SITE DRAINAGE ON LAND AT THE END OF KEMPLE VIEW

Subject: SITE DRAINAGE ON LAND AT THE END OF KEMPLE VIEW

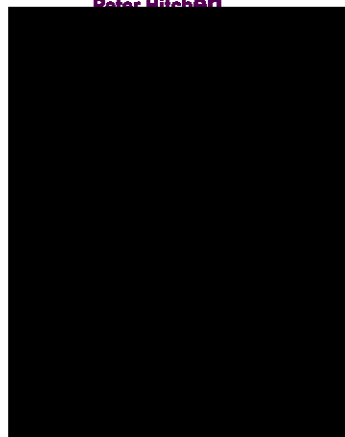
a revised plan which demonstrates the potential to divert the highway drain around

house plot 2 as shown.

We have based the plan on the basis that there will be a connection point on the southern boundary following the installation of a concrete ring chamber on the adjoining land as discussed.

Our client will be installing a new compliant chamber on their land as shown and the drain line will have a 3m easement either side.

The excavations will need to be carried out in strict accordance with your requirements and we are aware that the diverted drain is close to an existing UU drain position.

Please can you advise how we carry out site excavations in close proximity to UU pipes.

Please proceed with you application we are satisfied with your proposal for the diversion of the drain.
